CITY PLAN COMMISSION

FILE NUMBER: S245-004

REQUEST: An application to create one 0.240-acre (10,450 square foot) lot and one 0.196-acre (8,545 square foot) lot from a 0.436-acre tract of land in City Block 8605 on property located on Mountain Creek Parkway at Timberbluff Road, northwest corner.

1:2,400	<p style="text-align: center;">EXISTING AREA ANALYSIS MAP</p> <p> <input type="checkbox"/> Area of Request <input type="checkbox"/> Recent History </p>	Case no: <u> S245-004 </u> Date: <u> 10/18/2024 </u>
--	---	---

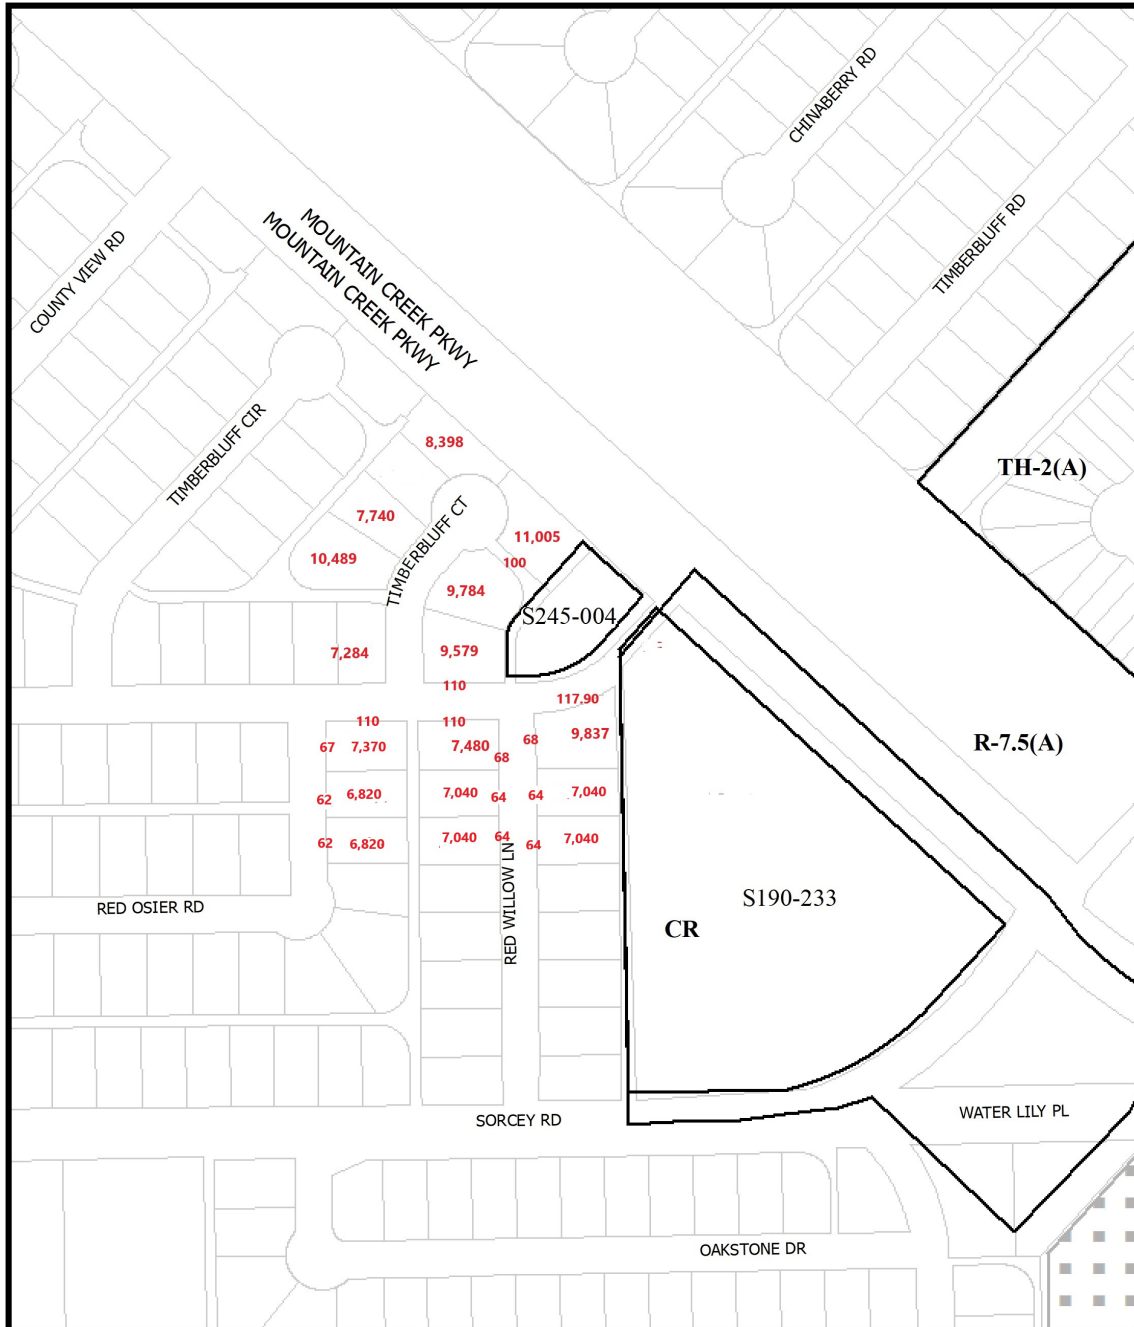
- The properties to the west and south of the request have lot areas ranging in size from 6,820 square feet to 11,005 square feet and widths ranging in size from 62 feet to 110 feet and are zoned R-7.5(A) Single Family District. (*Refer to the existing area analysis map*)

The request lies in an R-7.5(A) Single Family District which has a minimum lot area requirement of 7,500 square feet. The request is to create one 10,450 square foot lot and one 8,545 square foot lot; and the proposed lot widths are 88.70 feet and 109.06 feet respectively.

Staff finds that the request is compatible with the lot pattern already established in the adjacent areas; and the request is in compliance with Section 51A-8.503 and also with the requirements of the R-7.5(A) Single Family District therefore, staff recommends approval subject to compliance with the following conditions:
